OCONEE NUCLEAR STATION, UNIT NO. 1

AMENDMENT TO FACILITY OPERATING LICENSE

Amendment No. 92
License No. DPR-38

ATTACHMENT TO LICENSE AMENDMENTS

Figure 2.3-1A

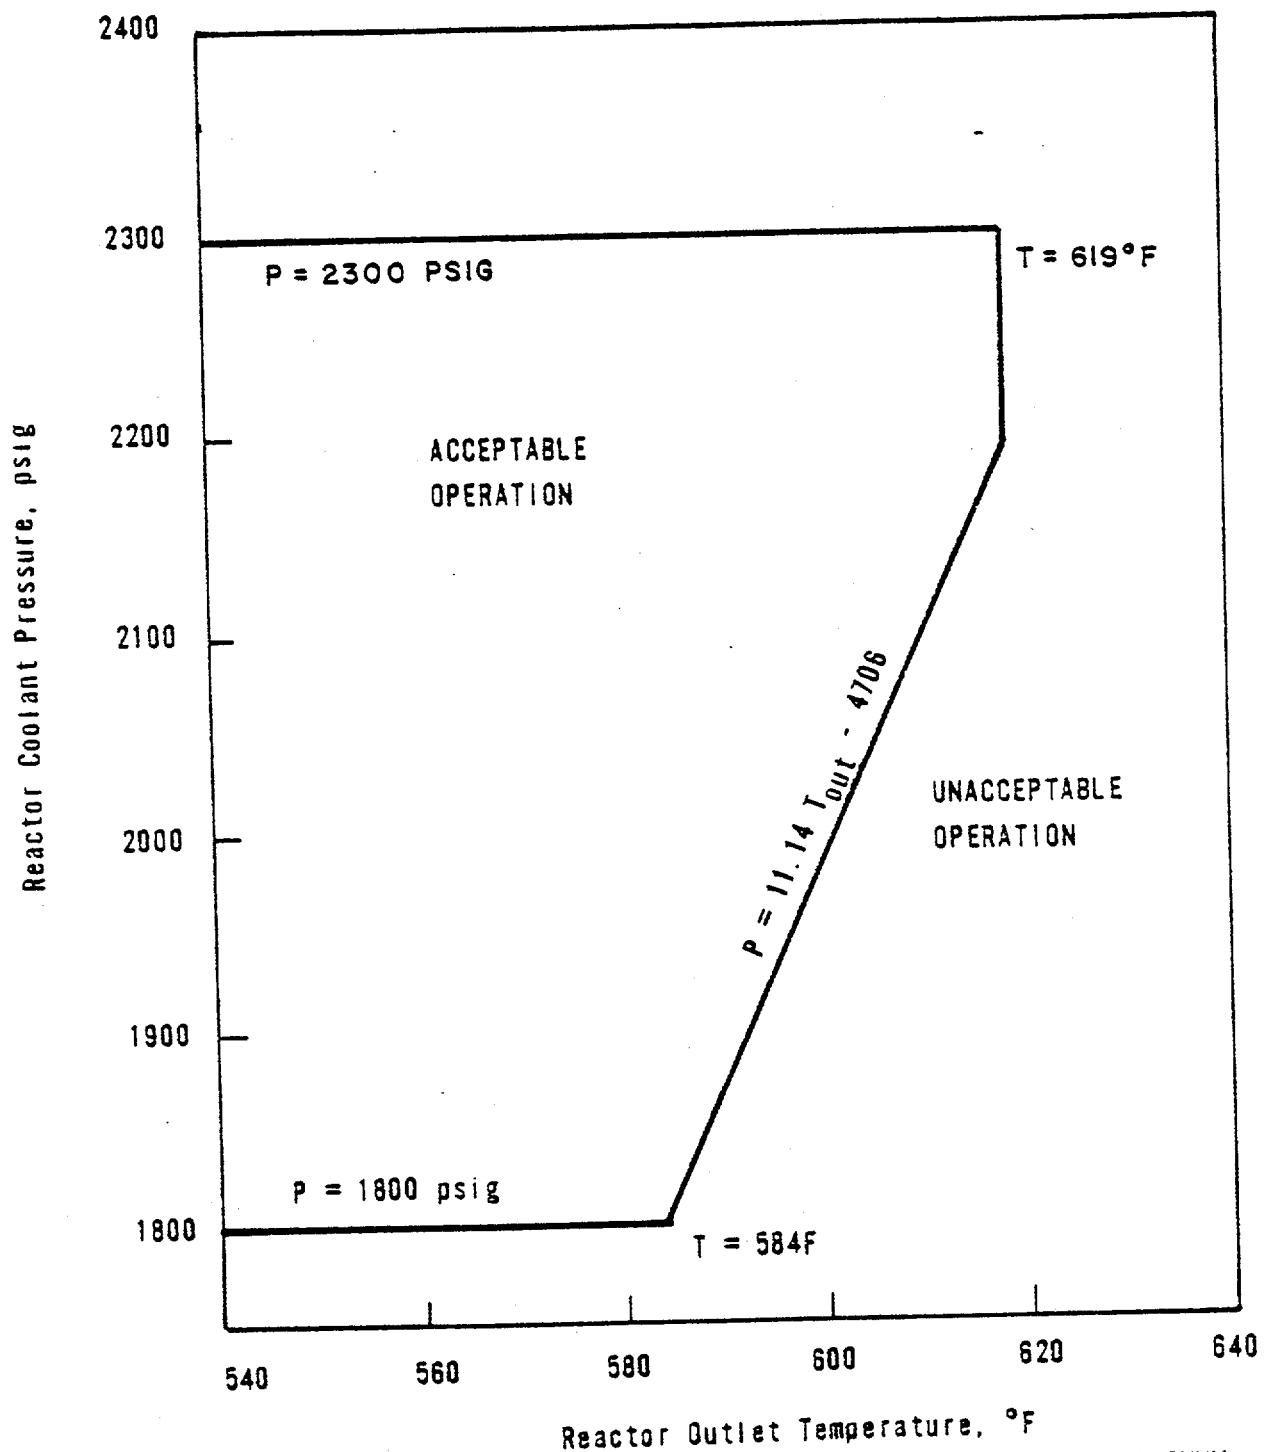
During a startup accident from low power or a slow rod withdrawal from high power, the system high pressure setpoint is reached before the nuclear over-power trip setpoint. The trip setting limit shown in Figure 2.3-1A - Unit 1

for high reactor coolant system pressure (2300 psig) has been established to maintain the system pressure below the safety limit (2750 psig) for any design transient. (1)

Figure 2.3-1B

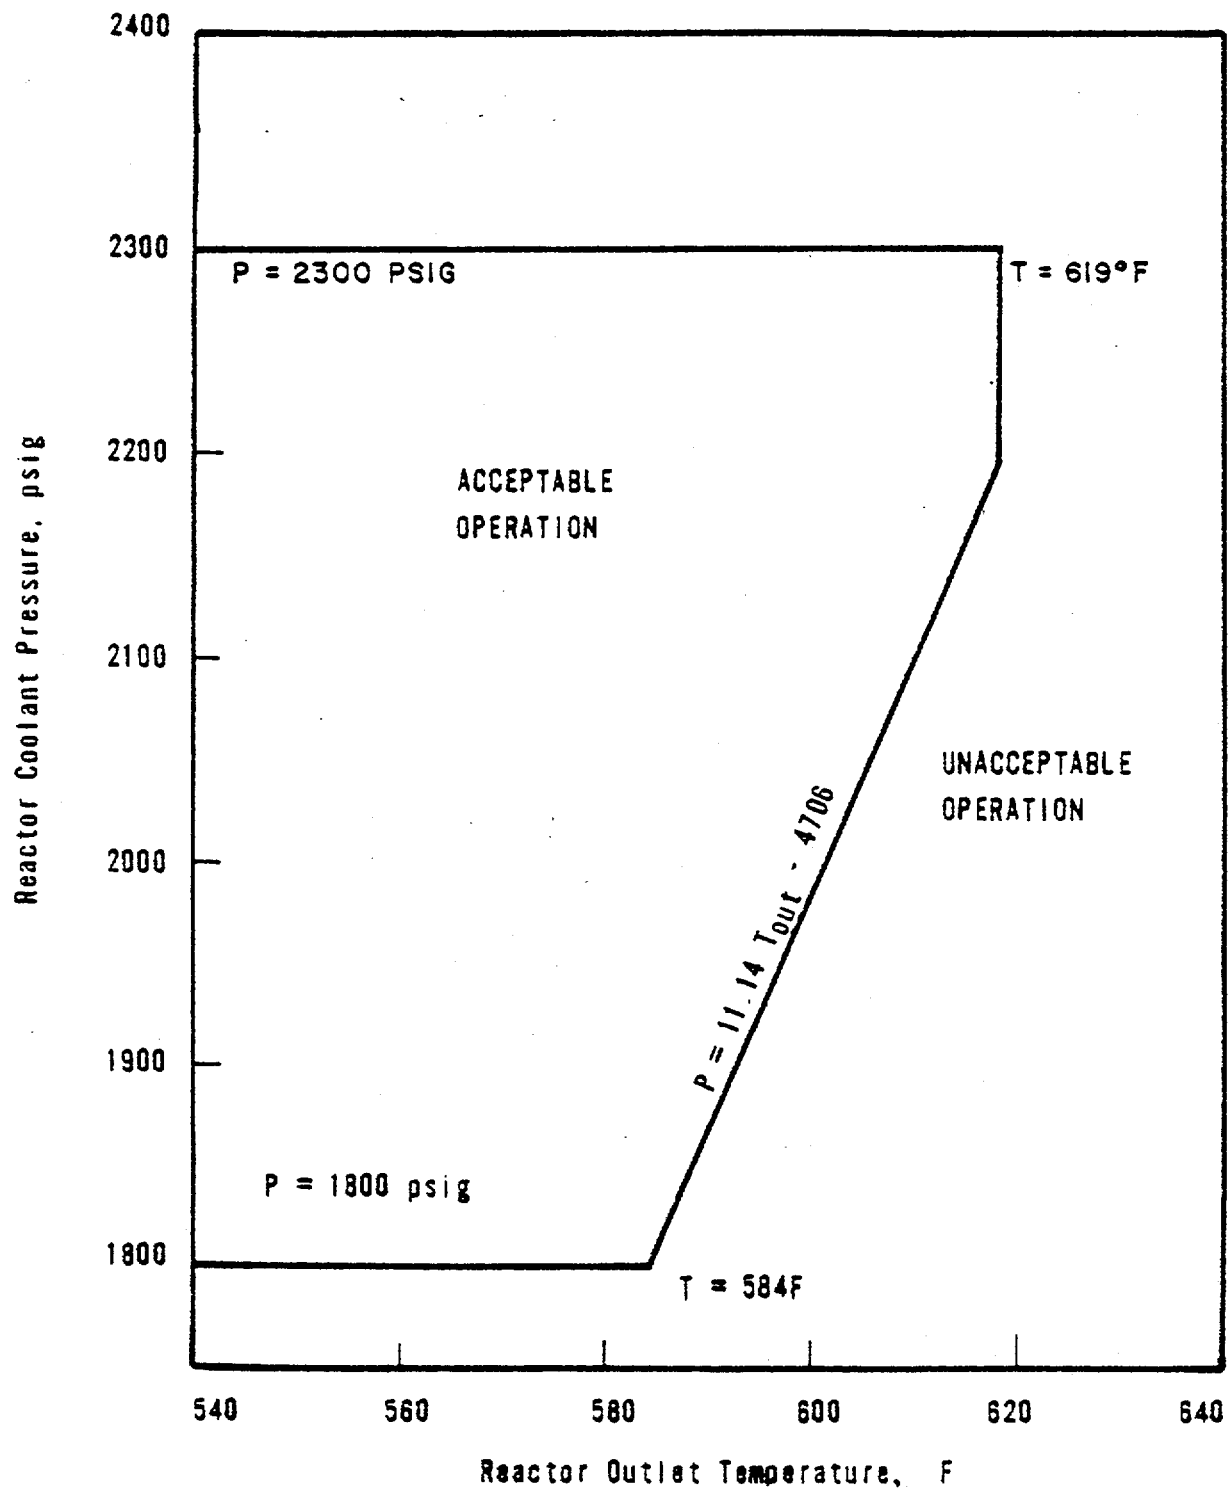
2.3-1B - Unit 2
